Appendix I – Road Safety Audit Designer’s Responses

Adastral Park, Ipswich : Traffic Signals Access off the A12 Dual Carriageway

Technical Note : Designer's Response to Road Safety Audits at Stage 1

14th June 2017

Appendix B: Updated Design Drawing

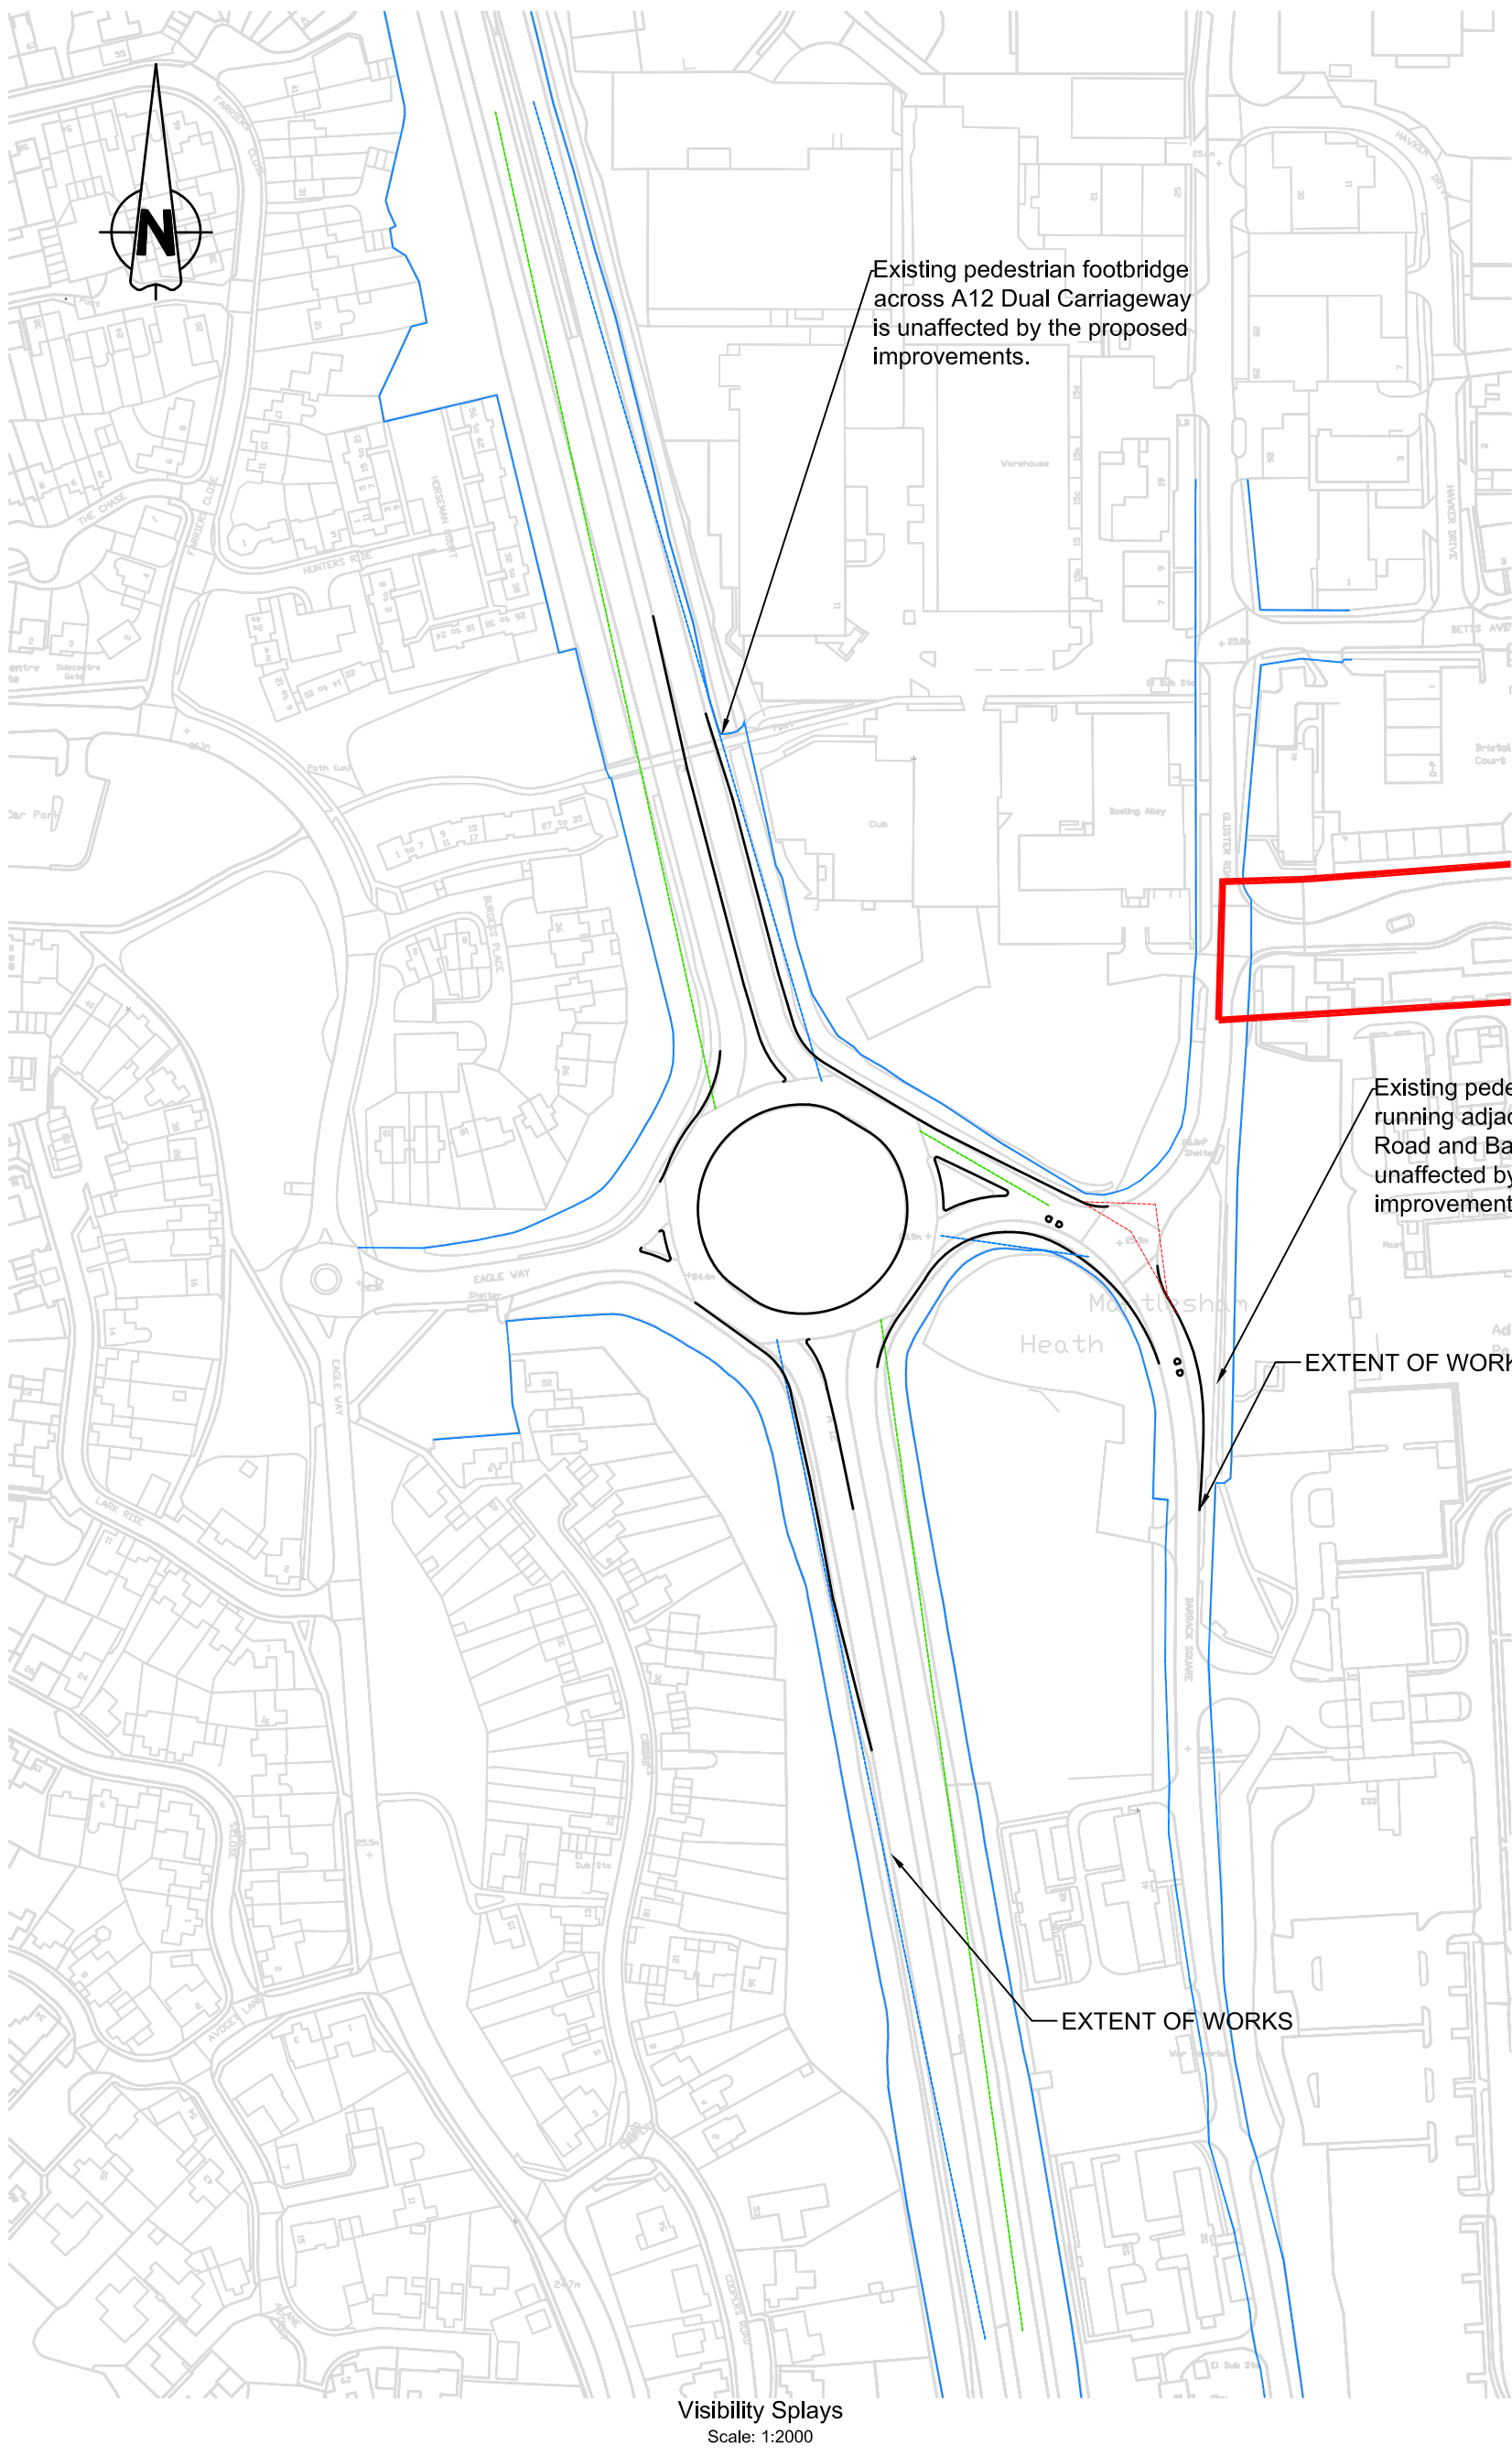
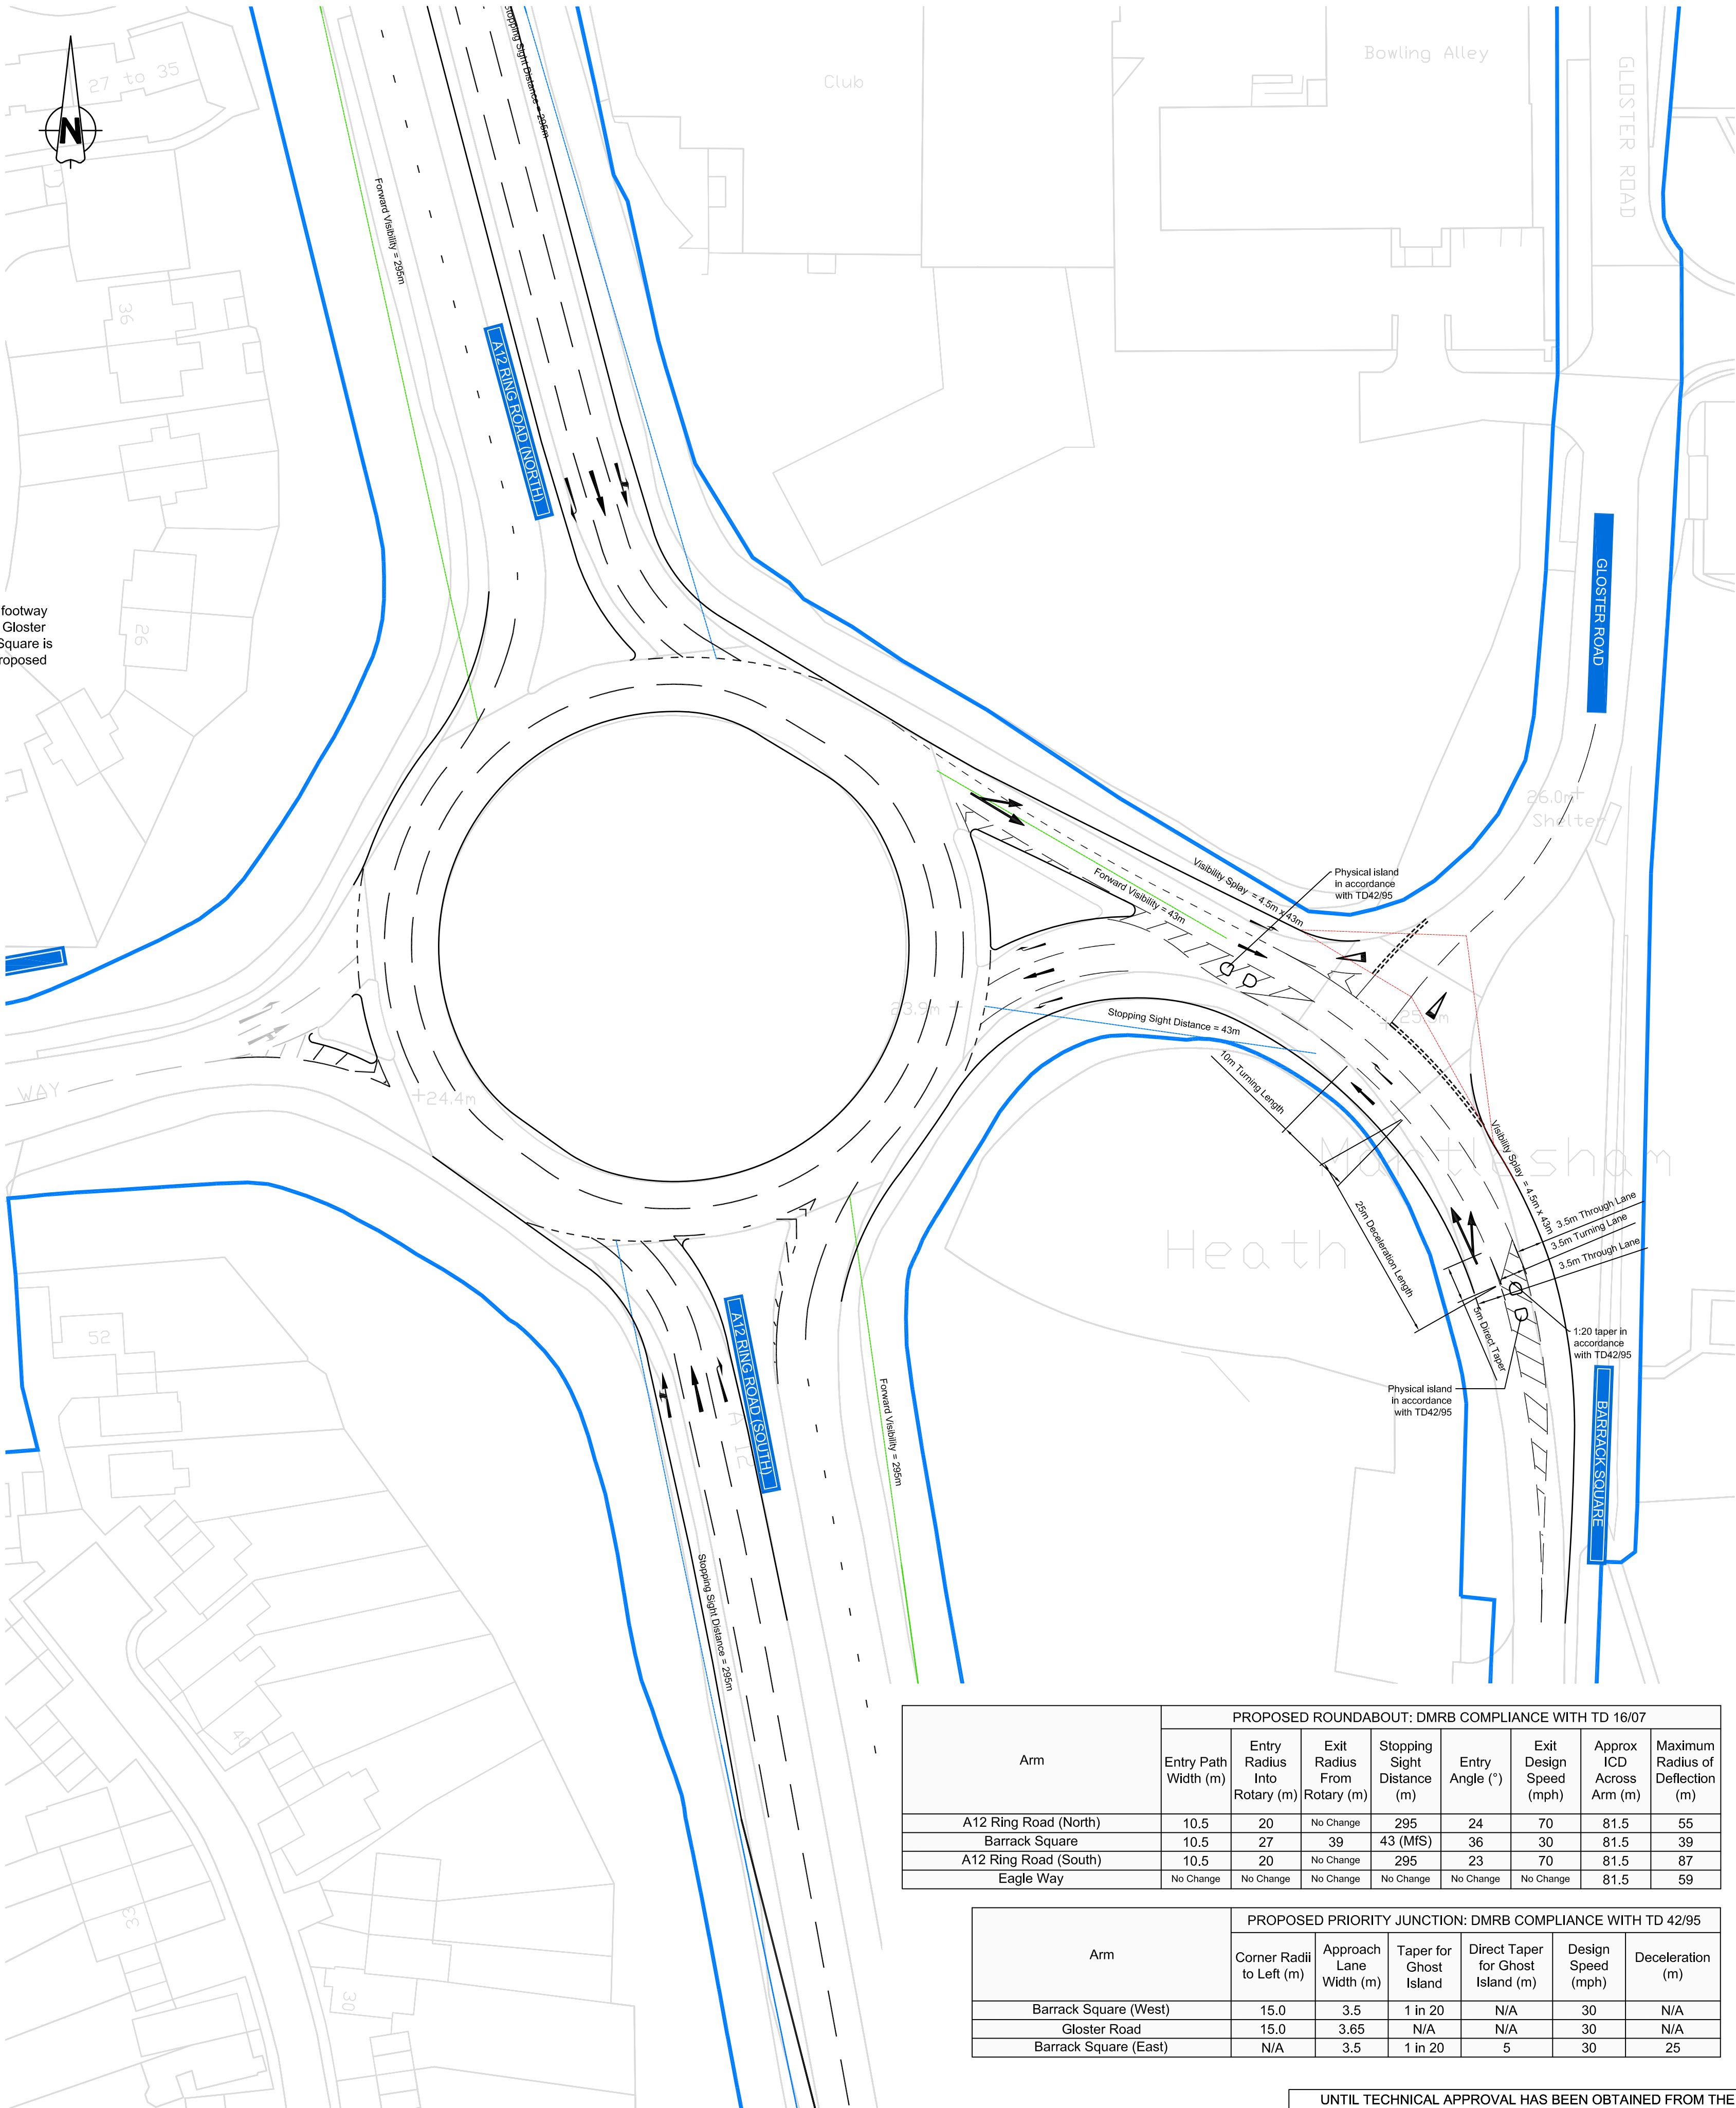
Recommendation: Provide traffic islands in the hatching at each end of the ghost island to clarify the layout and prevent deliberate misuse.

Summary: Risk of lane change accidents. There are two lanes on this exit, with a very short length for unfamiliar drivers to ascertain the correct lane to be in. This can lead to conflicts if drivers need to change lanes with a very short length to do so.

Recommendation: Provide a single lane on exit, developing the left turn lane immediately afterwards.

***BCL Response:** The approach entry kerb radii have been narrowed to the minimum advised value of 20m as per Paragraph 7.49 in DMRB standard TD 16/07 Geometric Design of Roundabouts. This will now achieve deflection on the approaching arm and therefore satisfy the mandatory requirements of Paragraph 7.56 in TD 16/07.*

***BCL Response:** Traffic islands have been provided to emphasize the layout of the two separate junctions and regulate traffic flow.*

***BCL Response:** The lane has now been amended to provide a hatched single lane on exit with an immediate flare into the nearside diverging taper.*
